SHEET TITLE
SITE PLANS
PROJECT ADDRESS
98 CUTLER ROAD,
CLONTARF

CLIENT
BOWES HOUSE
DOCUMENTATION
-

SCHEDULE OF MODIFICATIONS SOUGHT

1 EXISTING SITE PLAN
1 : 200

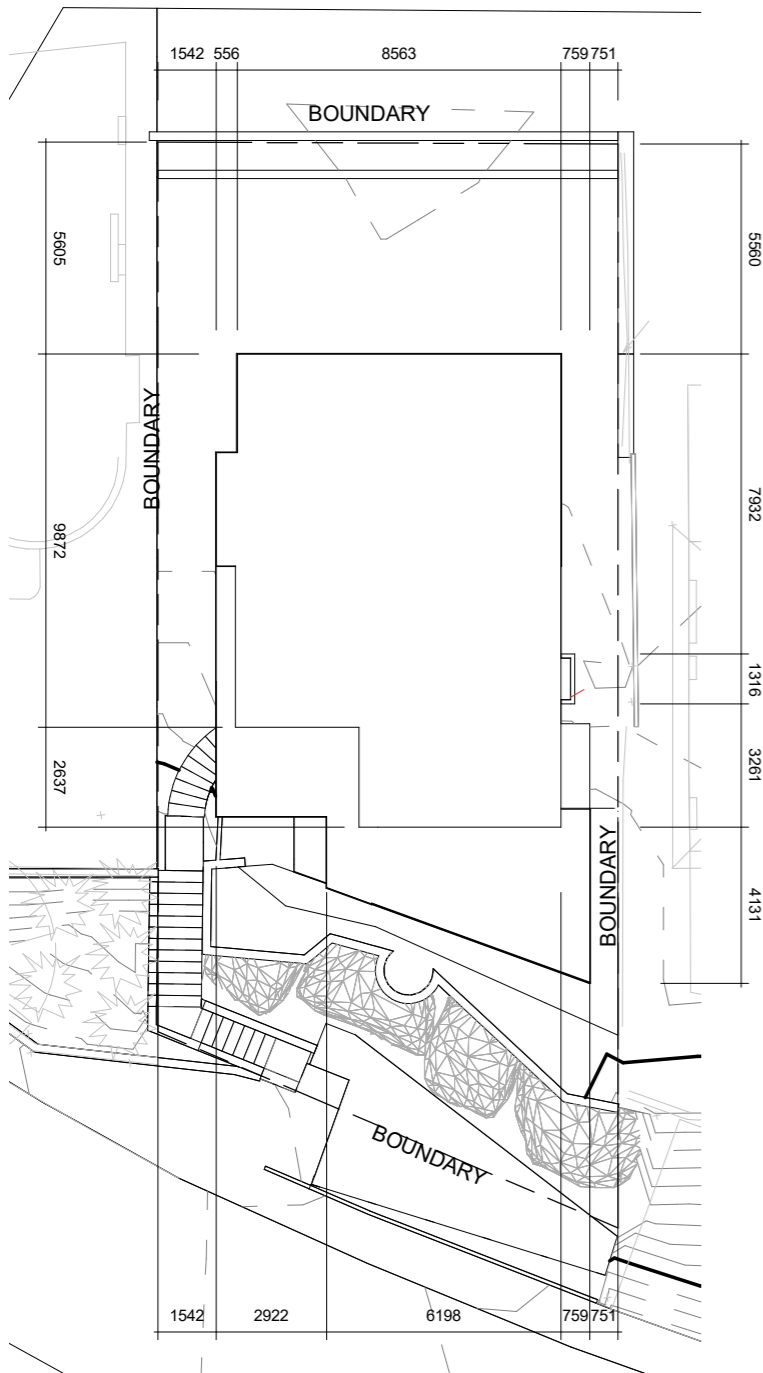
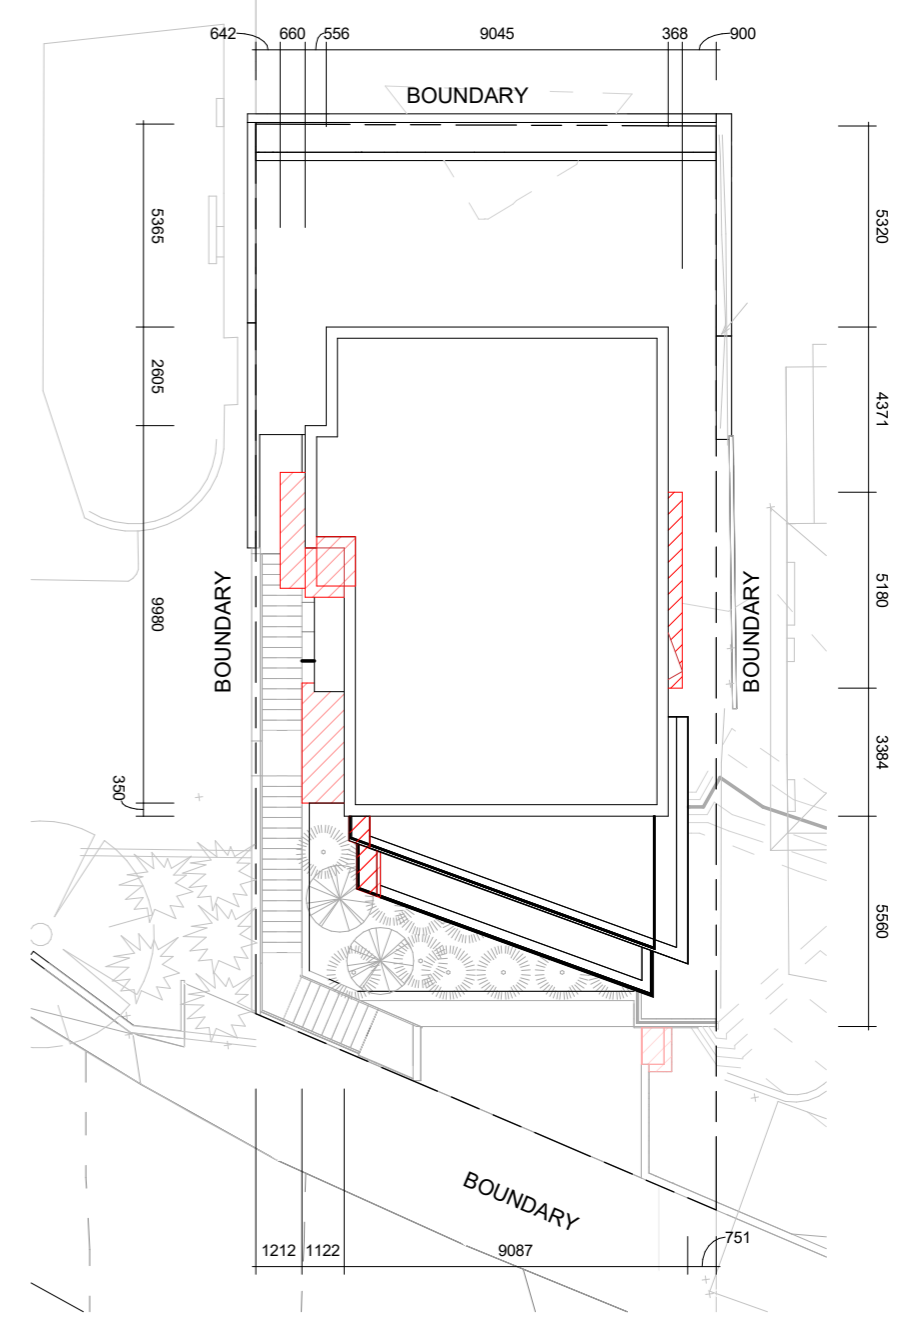
PROPOSED DEMOLITION SHOWN IN RED

MODIFICATIONS OUTSIDE OF THE FOOTPRINT OF THE APPROVED "DA 2018 / 0764" SHOWN IN RED HATCH

1 SITE PLAN
 1 : 100

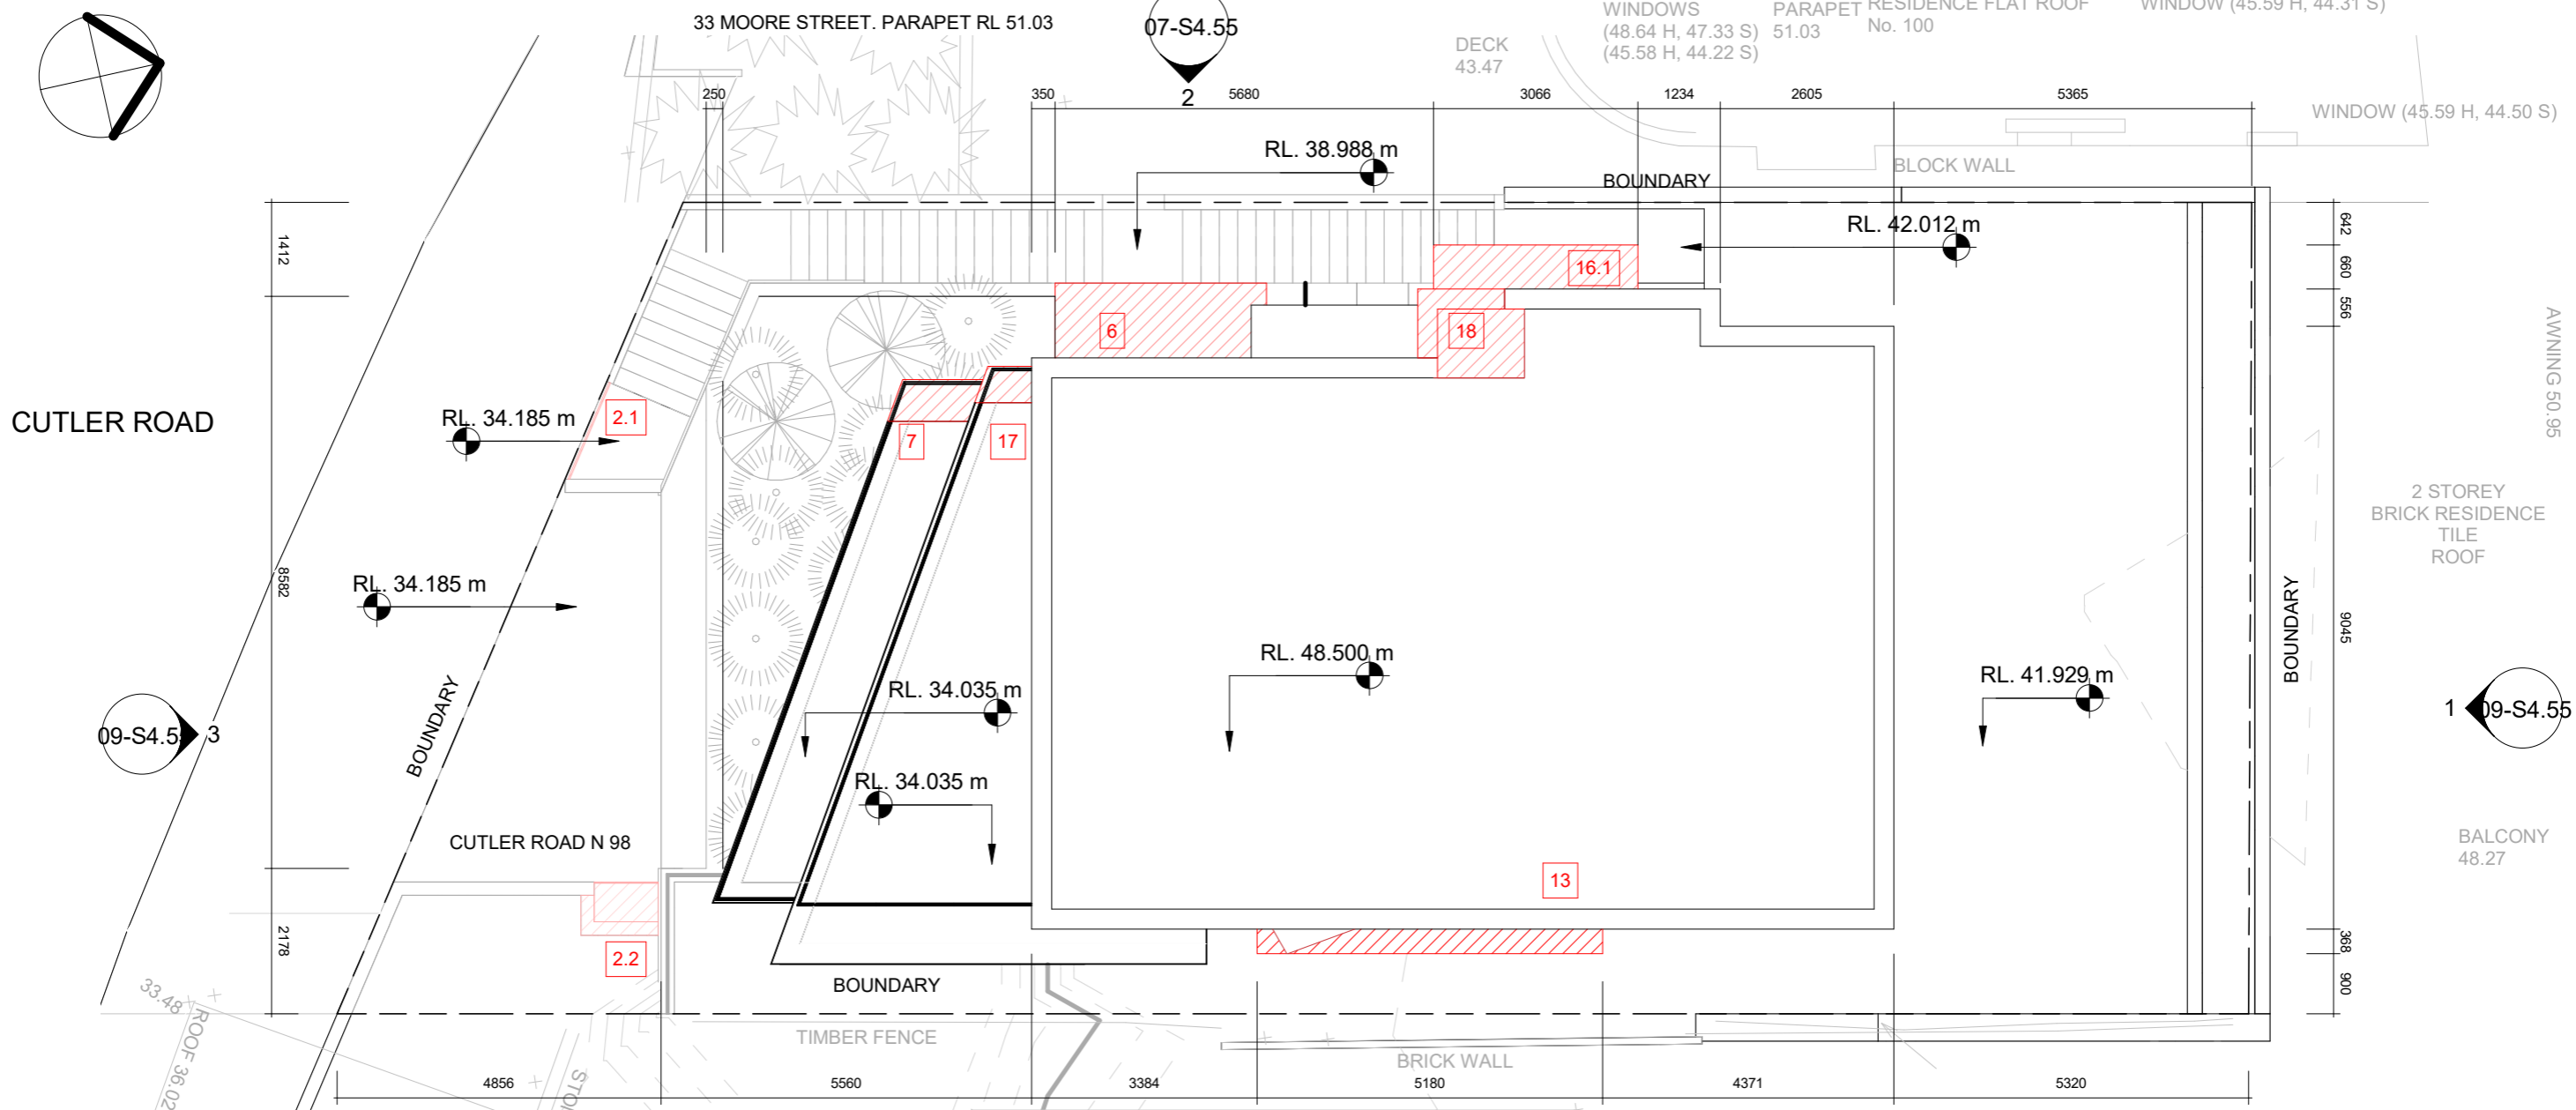
- 1. Proposed storage space
- 2.1 Proposed front boundary security gate
- 2.2 Gas - Electric and water meter

- 3. Modified Deck adjacent to suspended landscape garden & glass barrier.
- 4. Proposed structural blade wall
- 5. Proposed modified floor layout including additional bedroom and associated windows
- 6. Proposed ensuite 3 and associated windows
- 6.1 Structural column

- 7. Modified floor area to ensuite 1 and associated windows
- 8. Modified windows to Bed 2
- 9. Modified door and side-light height
- 10. Replace Bi-fold doors with window 3.6
- 11. Window location modified
- 12. Proposed external door
- 13. Proposed increase to Bed 3 floor area
- 14. Modified window height
- 15. Modified window height
- 15.1 Modified bedroom area
- 16. Modified Door heights
- 16.1 Concrete slab above entry

- 17. Extend terrace
- 18. Proposed additional floor area to kitchen + modified kitchen windows
- 19. Modified pantry window
- 20. Modified pantry window
- 21. Remove existing chimney
- 22. Modified window height
- 23. Modified door height

04 - Level 4

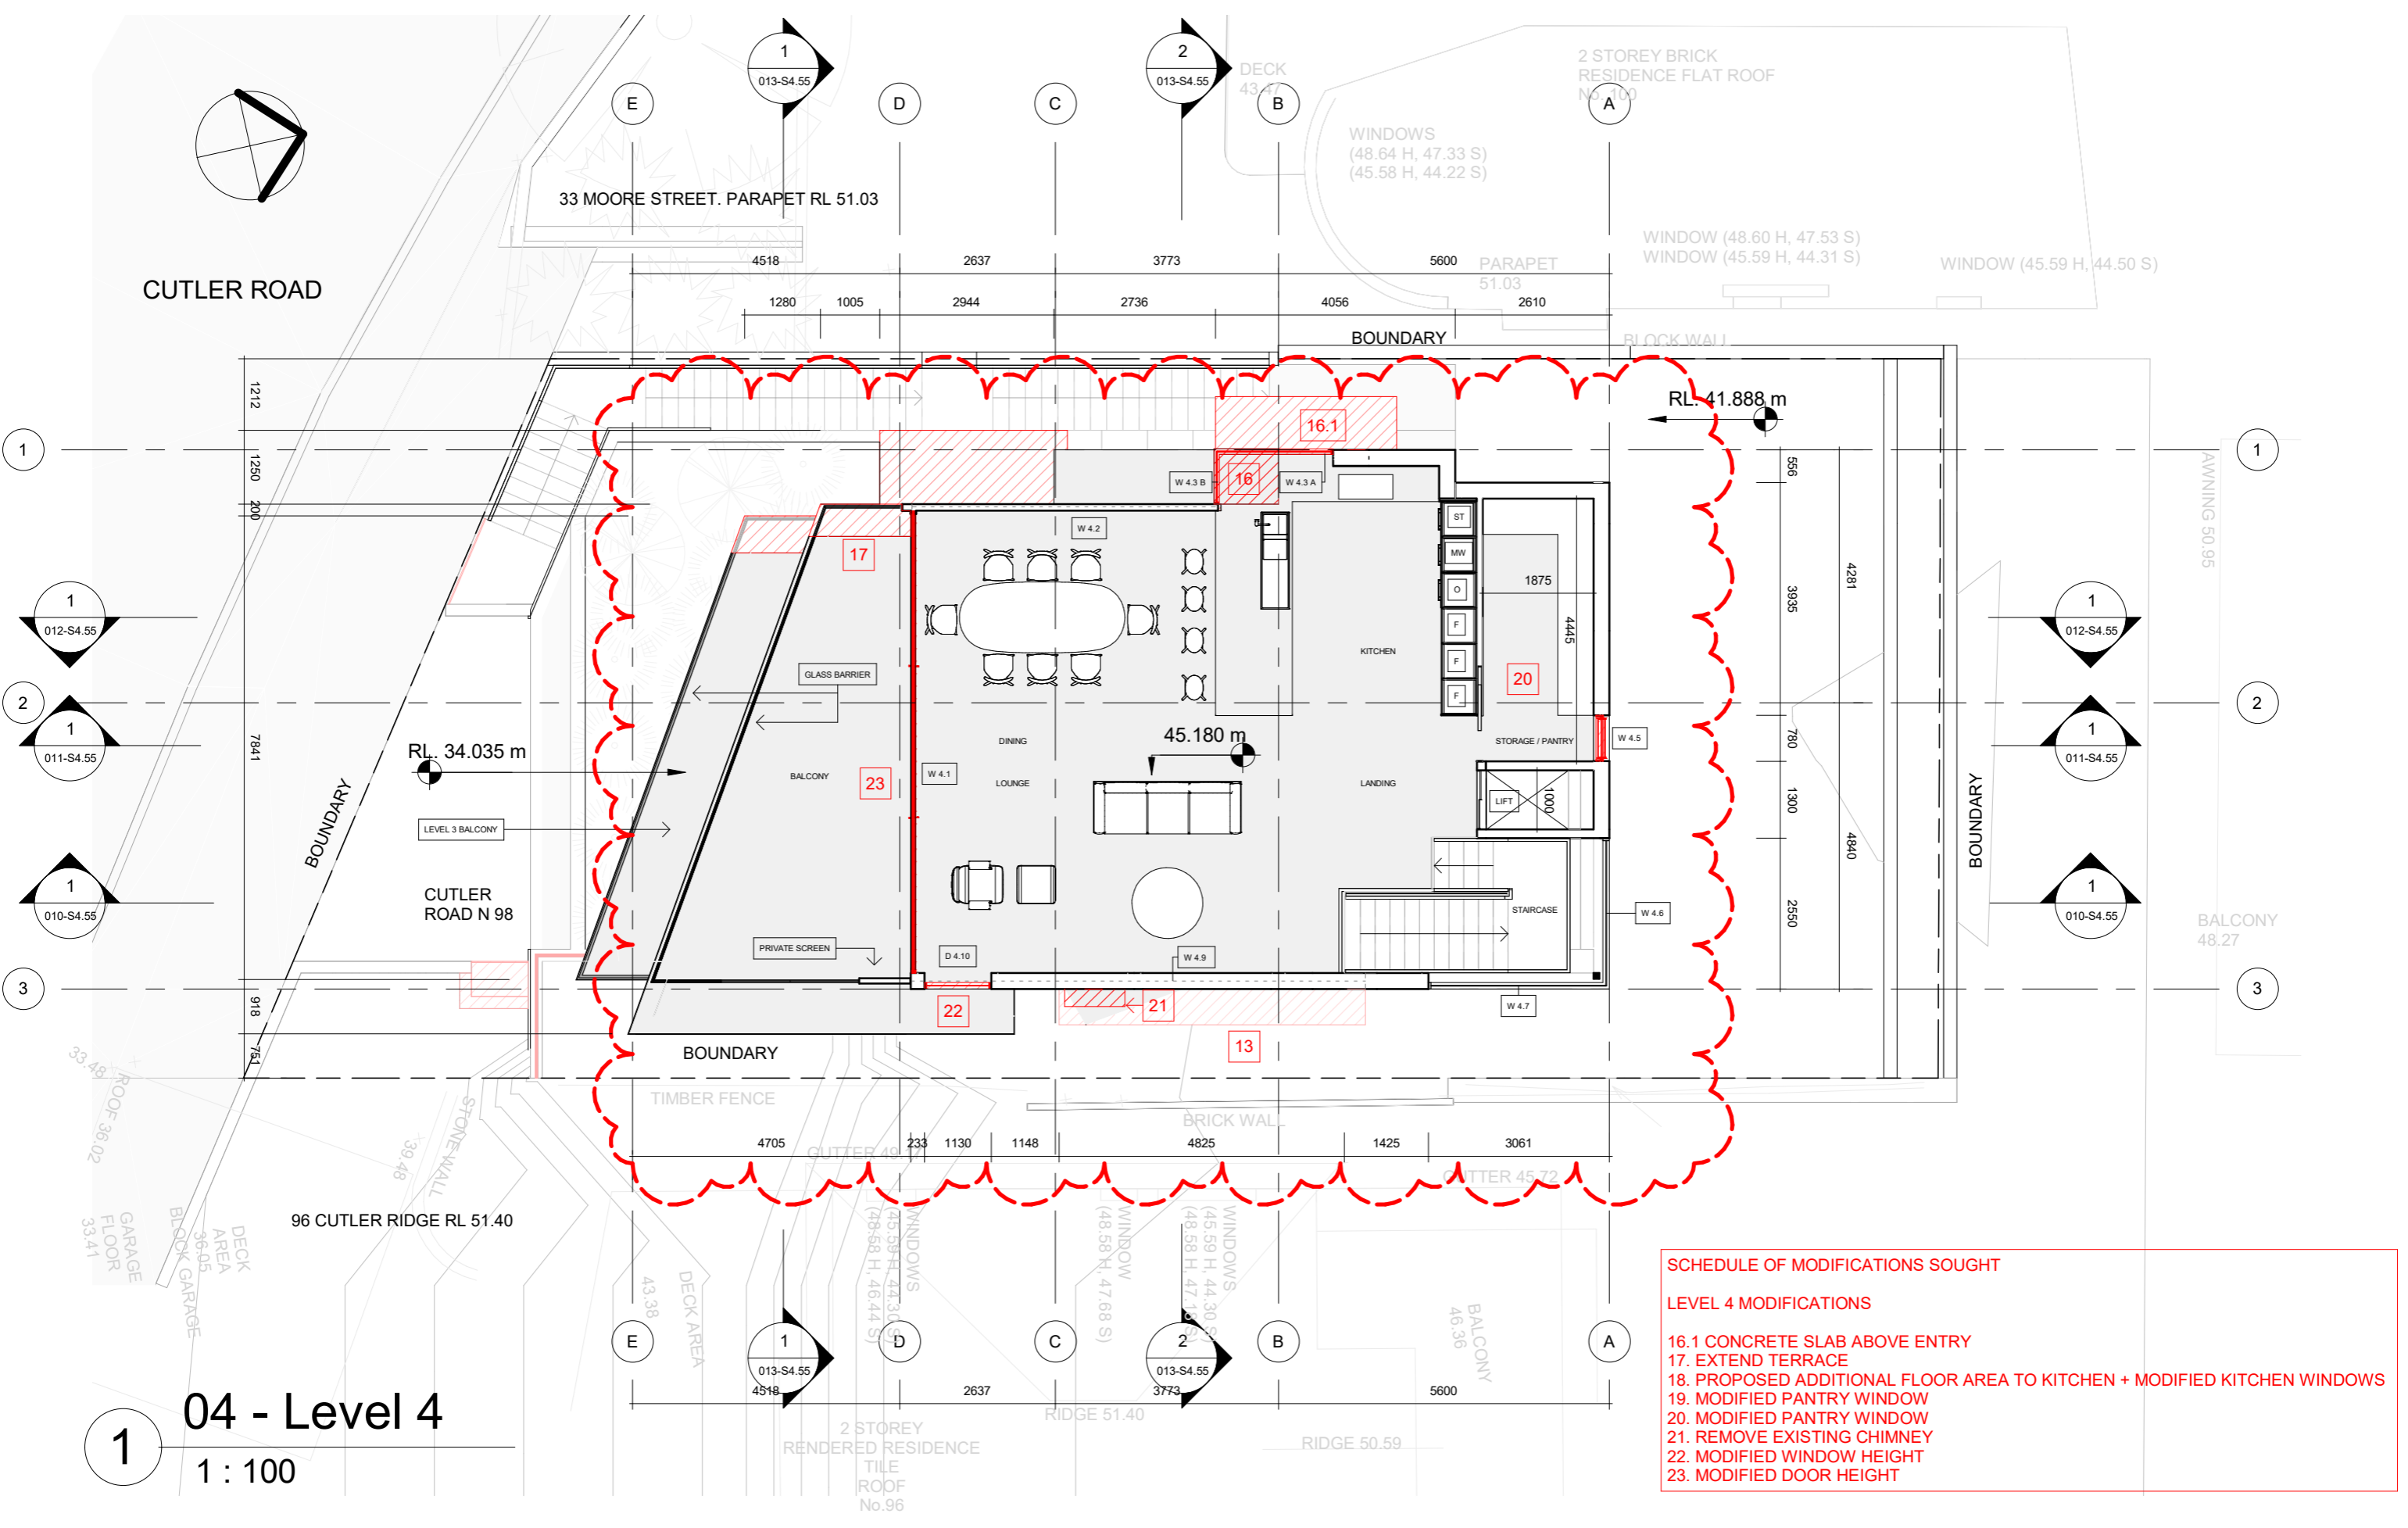
SCHEDULE OF MODIFICATIONS SOUGHT						
LEVEL 4 MODIFICATIONS						
16.1	CONCRETE SLAB ABOVE ENTRY					
17	EXTEND TERRACE					
18	PROPOSED ADDITIONAL FLOOR AREA TO KITCHEN + MODIFIED KITCHEN WINDOWS					
19	MODIFIED PANTRY WINDOW					
20	MODIFIED PANTRY WINDOW					
21	REMOVE EXISTING CHIMNEY					
22	MODIFIED WINDOW HEIGHT					
23	MODIFIED DOOR HEIGHT
